ADDENDUM No. 1

Date **Friday April 10, 2026**

Project: **CommuniHealth Monroe
1205 Louisville Avenue
Monroe, LA 71201**

3100 TRACTION ELEVATOR PLANS AND DETAILS

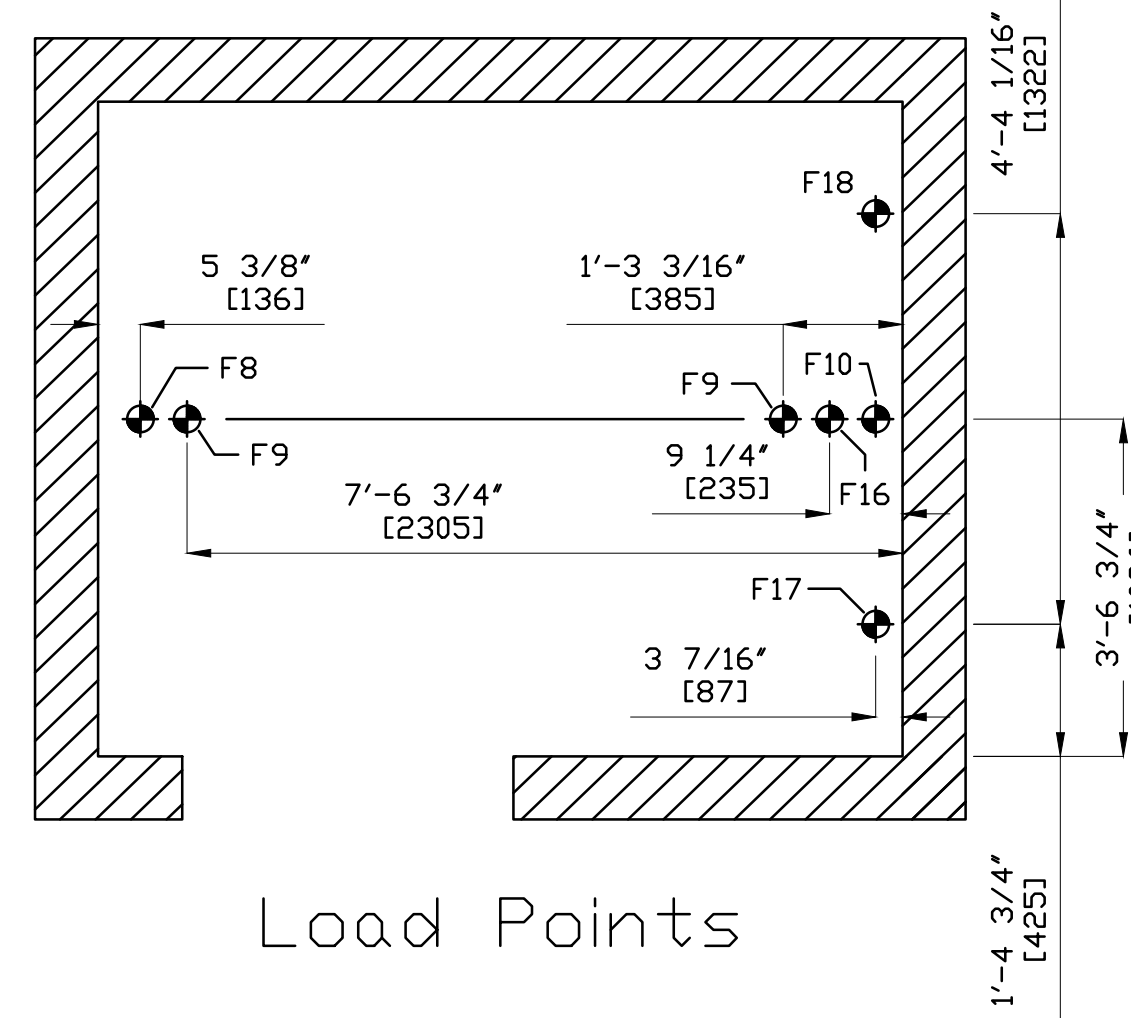
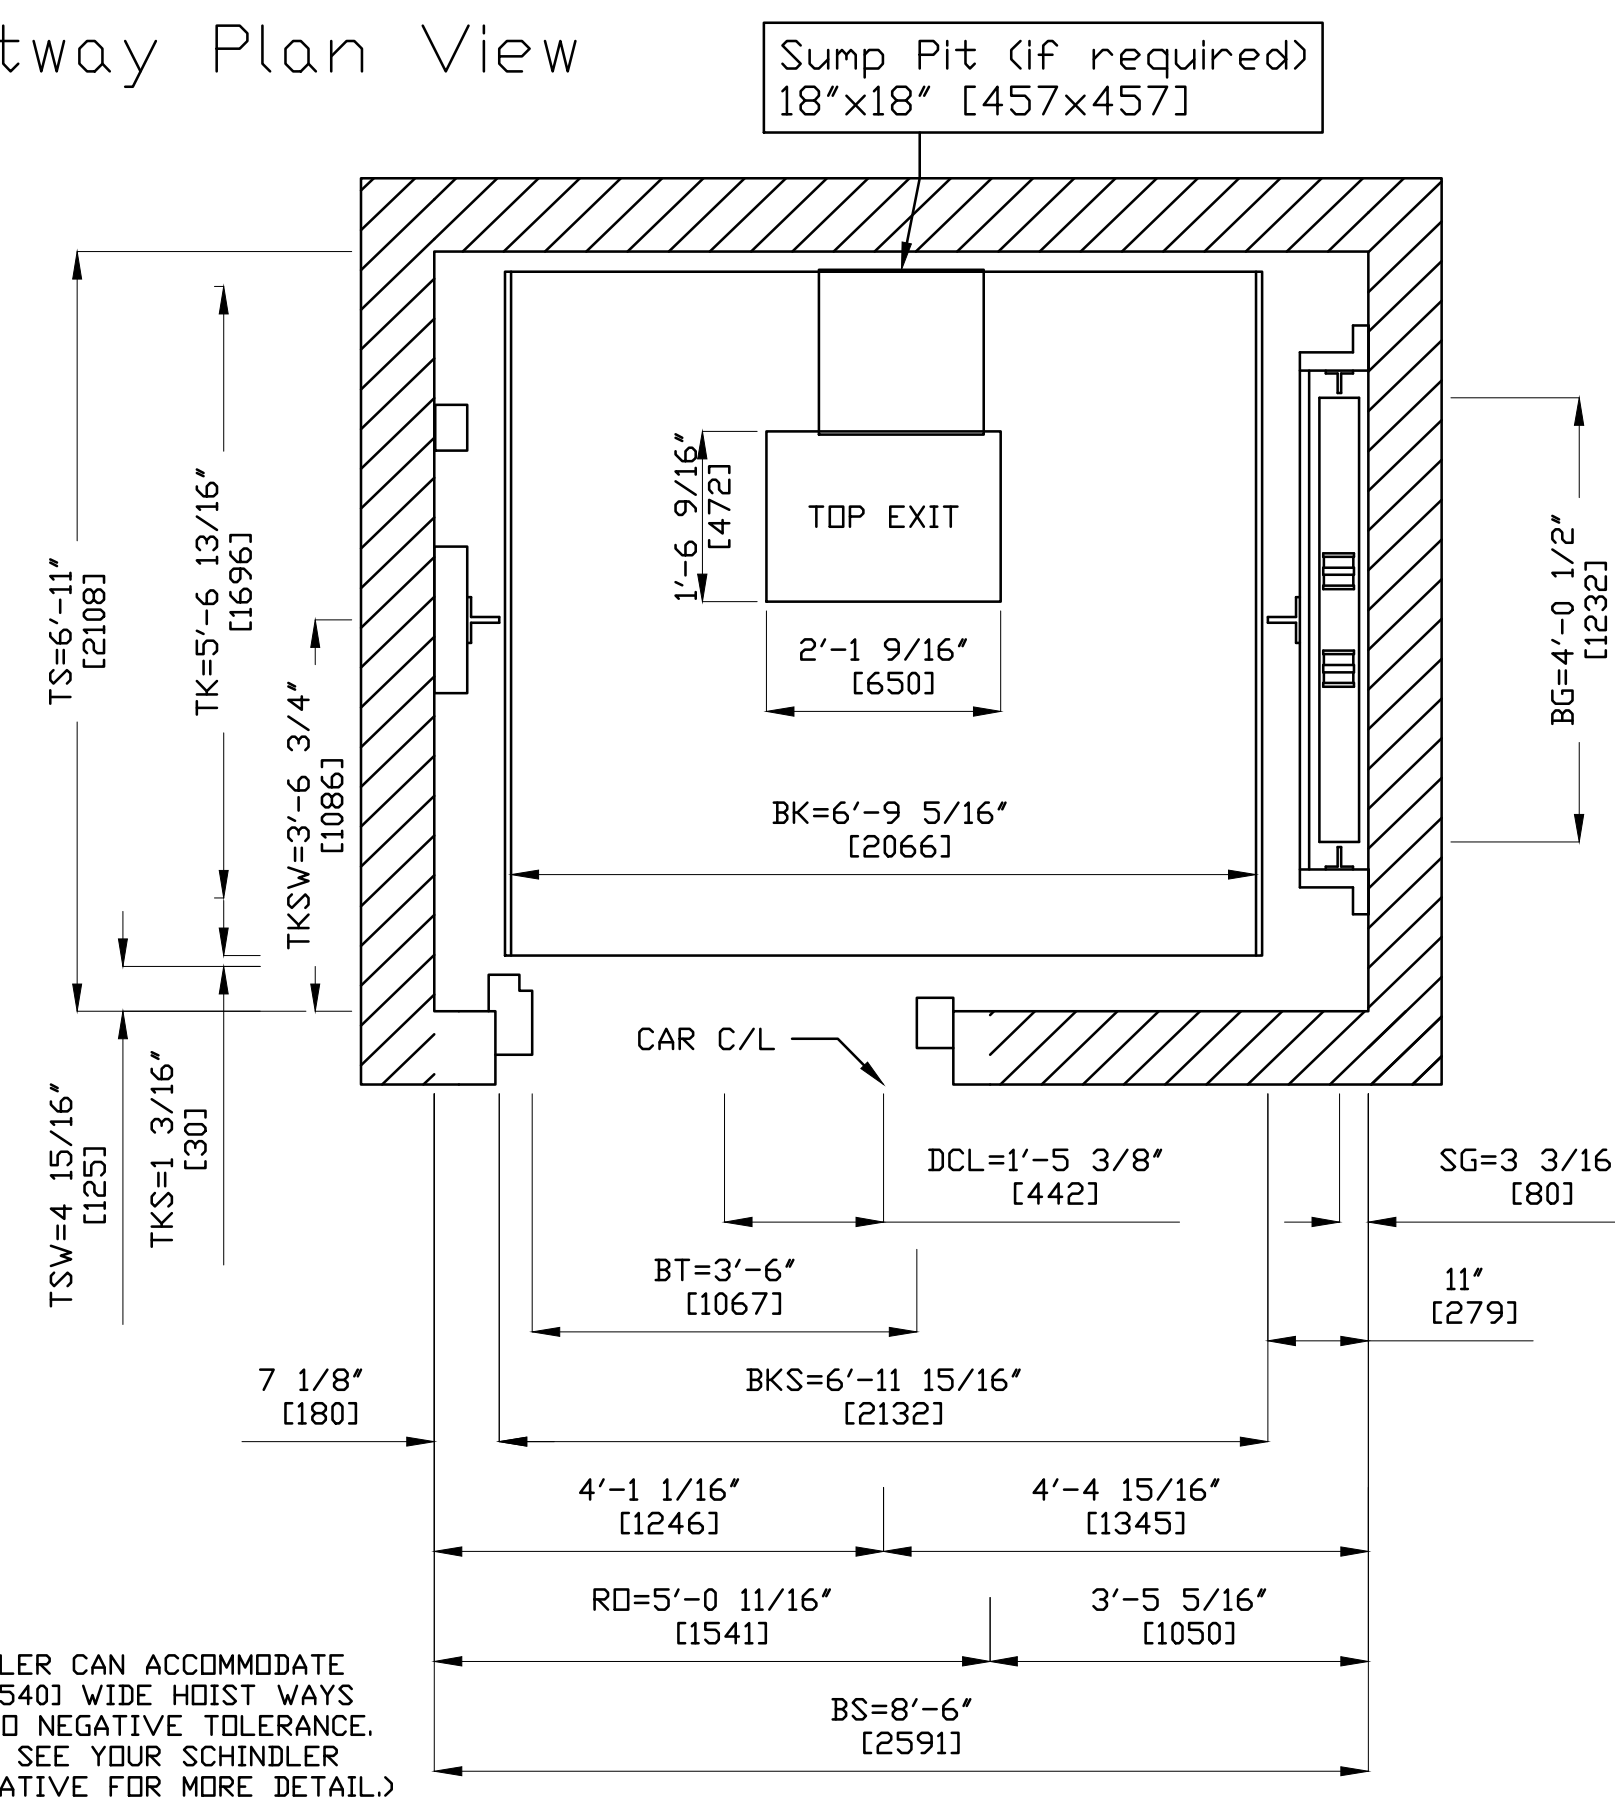
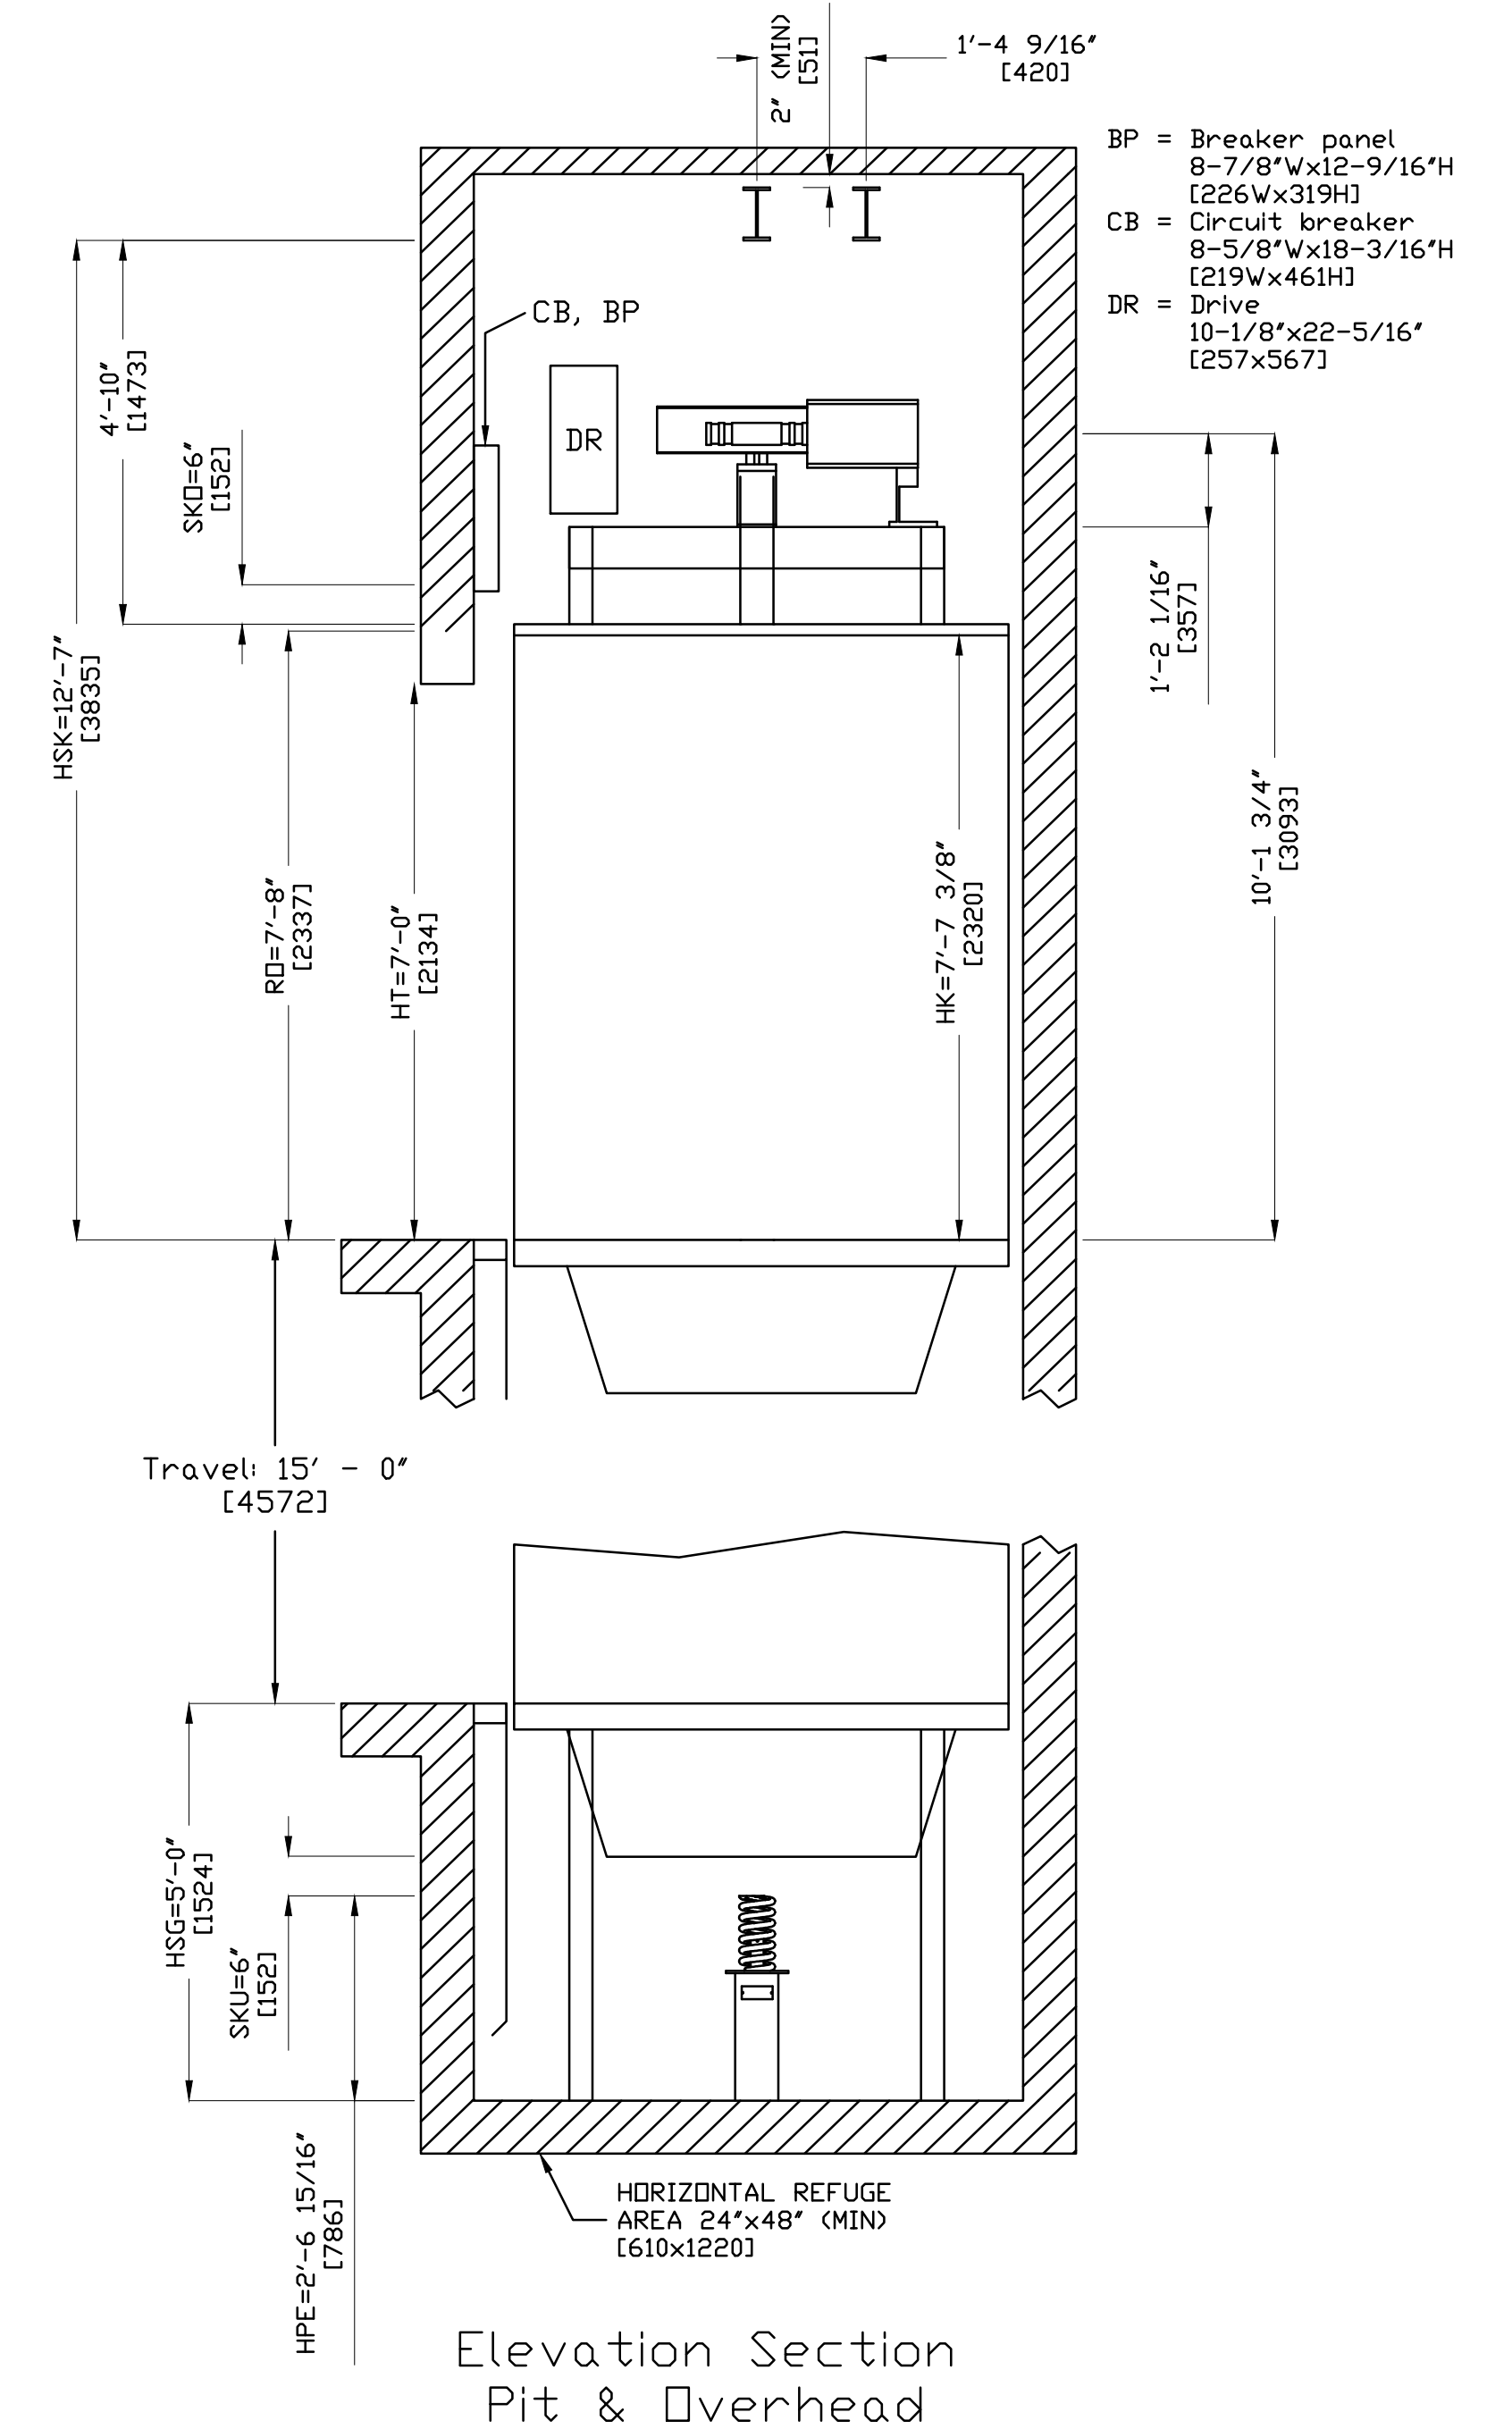
7. Please find included in this addendum the elevator cut sheets, per the Basis of Design. Please note that elevators now require two hoist beams and the clearance is now 12'-9" not 12'-7" shown on their cut sheet.
